Service Bulletin

Bulletin No.: PI0731A

Subject: Spare Tire Jack Storage Compartment Door Difficult to Latch or Falls Open Due to Inability to Latch

Models: 2009-2012 GMC Acadia

3136474

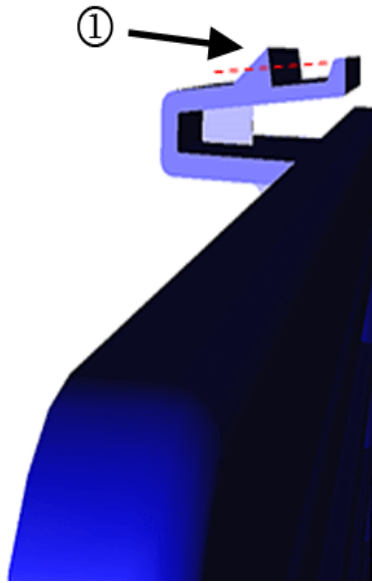
Note: The excessive flash may be folded back behind the panel and difficult to see, but it can still be detected by feeling the back side of the trim panel opening.

In many cases this interference is caused by excessive flash on the inside edge of the body side trim panel opening, preventing proper engagement of the latch.

Remove the storage compartment door and inspect the side trim panel opening for flash. If flash is present, it should be removed with a file inserted at a steep angle.
